FEEDWATER LINE VIBRATION PROBLEMS

Subject: Florida Power & Light Company
Turkey Point Units 3 & 4
Steam Generator Feedwater Piping

Attachments:
1. Sketch
2. W Letter dated January 10, 1974

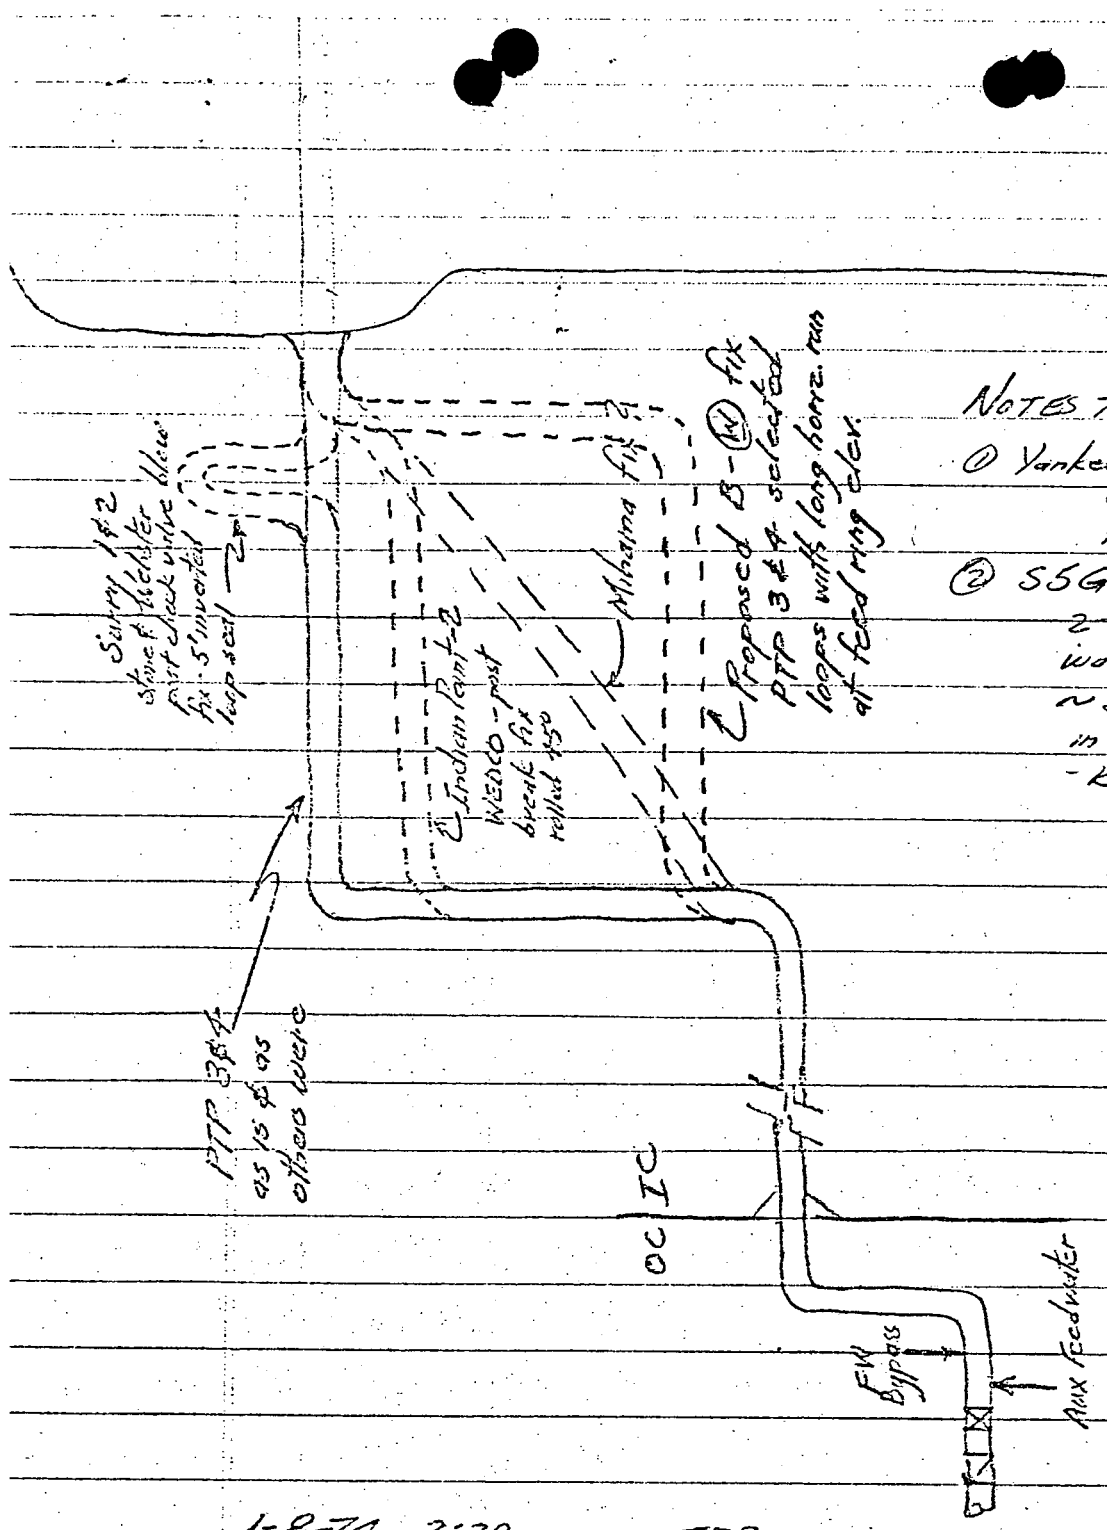
① Yankee Rowe FW lines modified some time ago for water hammer prob. – T. Lordi 1-9-74

② SSG plant - Idaho - 5" FW lines 2-loop sub prototype - had water hammer probs & added ~3' loop seal type mod. at SG in 1968 - fix solved water hammer - K.E. Beatty 1-9-74

Eliminate potential for steam entering horizontal run of feedwater line at the SG feedwater ring elevation by - in order of pref.

1. 90° down at SG, vertical as far as possible, then run to existing line.
2. 45° or some ∠ down at SG, run on slope to existing line.
3. Install conventional loop seal (i.e. loop down) at SG.
